**STAFF REPORT  
KETCHUM PLANNING AND ZONING COMMISSION  
MEETING OF FEBRUARY 11, 2024**

**PROJECT:** Knob Hill Residence

**FILE NUMBER:** P24-087

**APPLICATION TYPE:** Pre-Application Mountain Overlay Design Review

SHEET 3 OF 4  
**L-2.00**

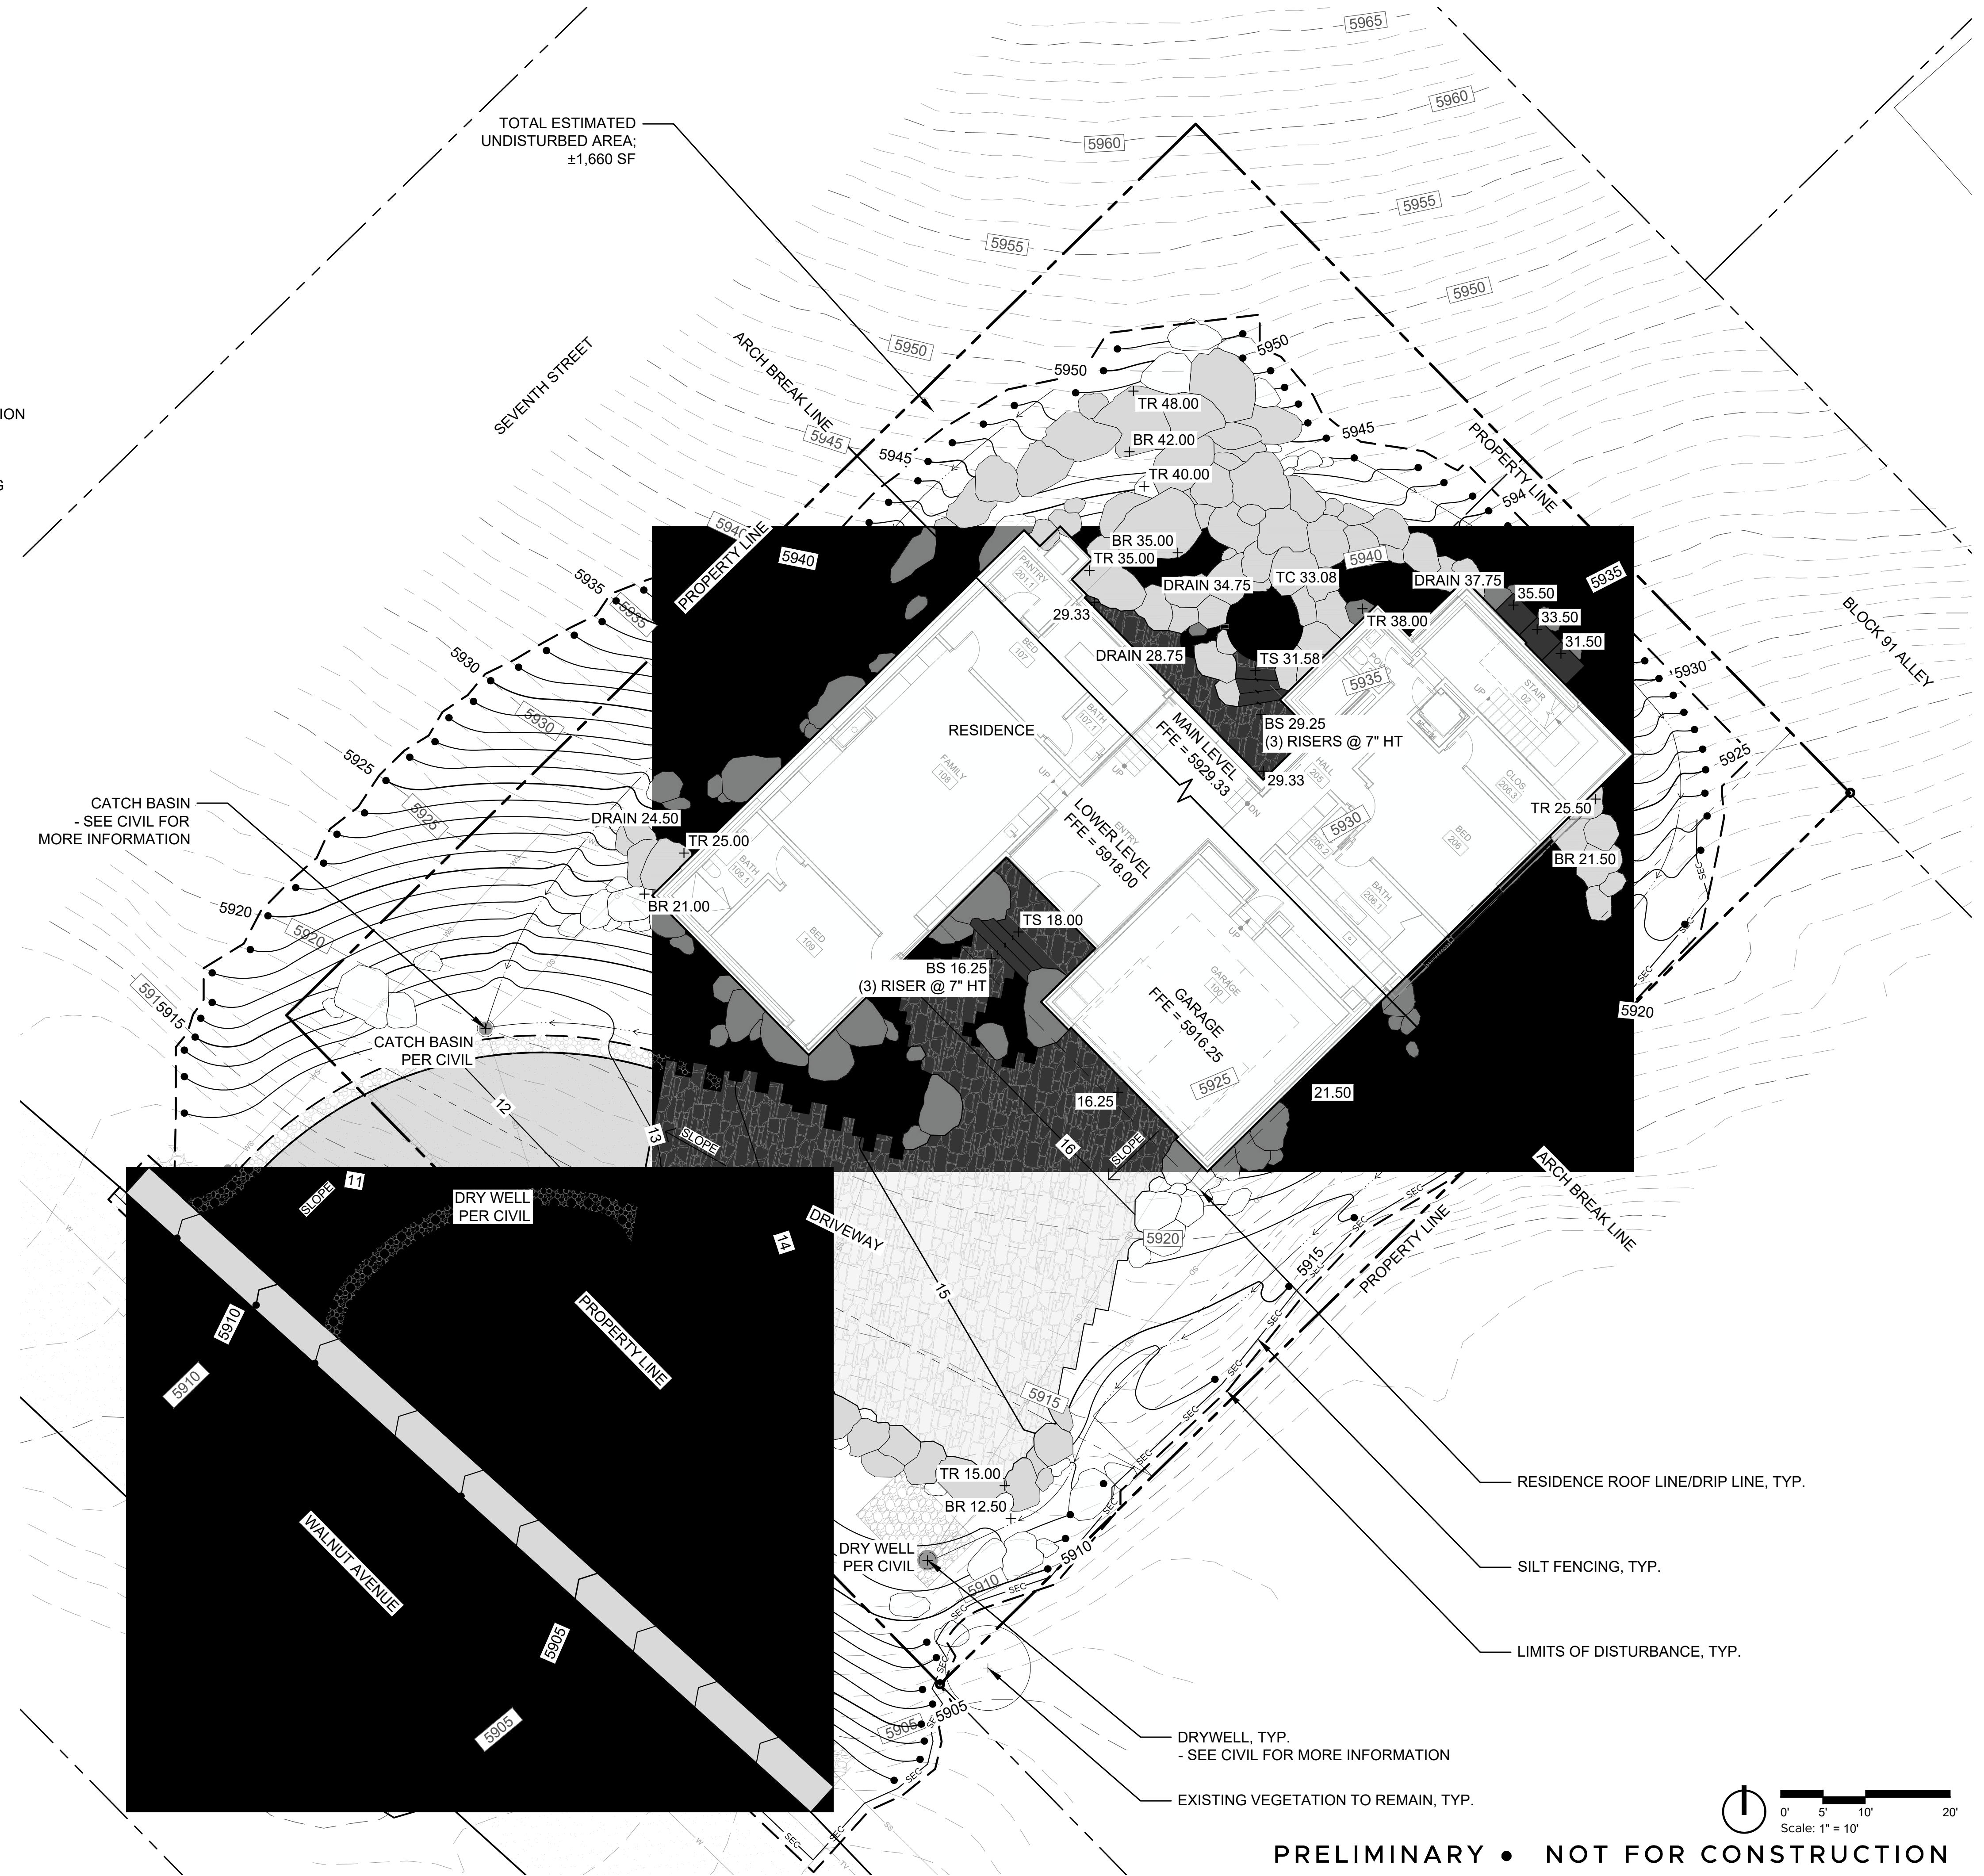
17.104.070.A13	<b>Limits of disturbance shall be established on the plans and protected by fencing on the site for the duration of construction.</b>
Staff Analysis	The proposed limits of disturbance is shown on sheet L-2.00 of the project plans. A construction management plan that addresses all construction activity standards specified in KMC §15.06.030 will be required to be submitted with the building permit application. KMC §15.06.030.J4 requires that, "Projects in the Mountain Overlay Zoning District or containing slopes greater than 25 percent shall be fenced pursuant to the design review
